UNITED STATES PATENT AND TRADEMARK OFFICE

APPLICATION NO.	FILING DATE	FIRST NAMED INVENTOR	ATTORNEY DOCKET NO.	CONFIRMATION NO.
09/847,901	05/02/2001	Masajiro Inoue	SIW-008	7510

Office Action Summary	Application No. 09/847,901	Applicant(s) INOUE ET AL.	
	Examiner Raymond Alejandro	Art Unit 1745

FIG. 3

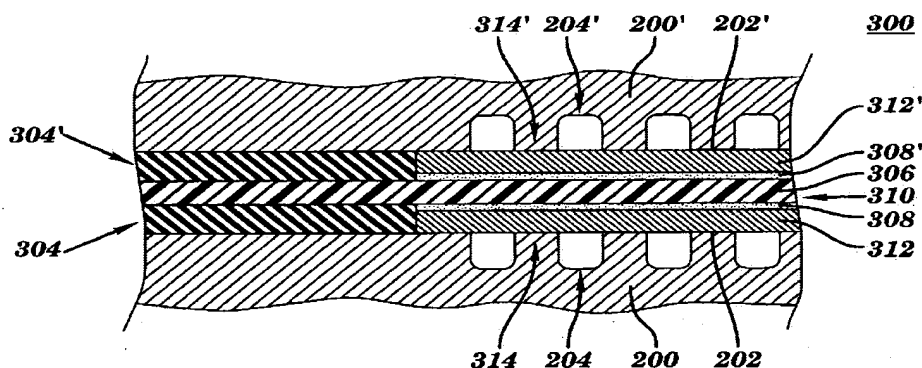
As seen in Figure 3, fuel cell 300 includes the membrane electrode assembly (MEA) 310 comprising a solid polymer electrolyte 306, catalyst 308 and 308' which facilitate chemical reaction are applied to the anode and cathode sides, respectively of the solid polymer electrolyte. This unit can be referred to as a membrane electrode assembly (col 6, line 56 to col 7, line 4). The MEA is sandwiched between anode and cathode gas diffusion layers 312 and 312', respectively (col 7, lines 5-8).

For purposes of illustration, Figure 3 also depicts the fuel cell with fluid flow plates 200 and 200' serving as flow field plates (it is noted that separator plates are sometimes referred to as flow field plates, that is, separator plates are also conventionally known in the art as flow

field plate), in particular, flow field plate 200 might serve as an anode side of the fuel cell, and flow field plate 200' might serve as a cathode side of the fuel cell. That is, face 202 might comprise an anode face, and face 202' might comprise a cathode face (col 6, lines 44-50).

Jones discloses that gasketing material or gaskets 304, 304' can be employed to seal peripheral holes. A given gasket might take the form of, for instance, a frame gasket made from polytetrafluoroethylene material (col 6, lines 34-42). As depicted in Figure 3, the gasketing material 304, 304' contacts the end faces of both gas diffusion layers 312 and 312'.

As illustrated in Figure 3, the edge of solid polymer membrane 306 extends beyond (extended/projecting portion) the end faces of the anode and cathode side; and the gasketing material 304, 304' contacts the extended portion of the solid polymer electrolyte.

As depicted in Figure 3, the gasketing material 304, 304' contacts the end faces of both gas diffusion layers 312 and 312'.

As shown in Figure 3, the gasketing material 304, 304' contacts the end faces of both gas diffusion layers 312-catalyst 308 and gas diffusion layers 312'-catalyst 308' which are considered to be the anode and cathode electrode sides, respectively.

【 図 2 】

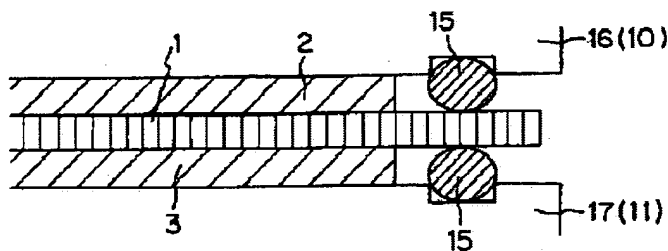
The JP'169 publication illustrates in Figure 2 a fuel cell structure including gas diffusion electrode wherein the separators 16, 17 provide grooves which are contacted and sealed by O-ring seals 15 (Figure 2 and section 0008).

In view of the above, it would have been obvious to one skilled in the art at the time the invention was made to seal Jones' separators by providing grooves thereon (*seal provided in grooves in the separator to seal them*) so as to obtain a seal-groove sealing structure as taught by

the JP'169 publication as the JP'169 publication teaches that when plates or frames (separators) constitute the main enclosing member of the fuel cell structure, an O-ring seal disposed between grooves formed in the separator enhances and ensures the adhesion of both separators. Further, the O-ring-grooves sealing feature provides a sealing technique having the advantage of employing adhesive forces without damaging fuel cell elements. Thus, this provides a sealing feature that ensures a sufficient sealing effect only through light pressing of the polymeric electrolyte film of fuel cell, and preventing damages to the electrolyte film per se. *The teaching of JP'169 is also consistent with another embodiment of Jones teaching and encompassing the employment of O-ring gaskets.*
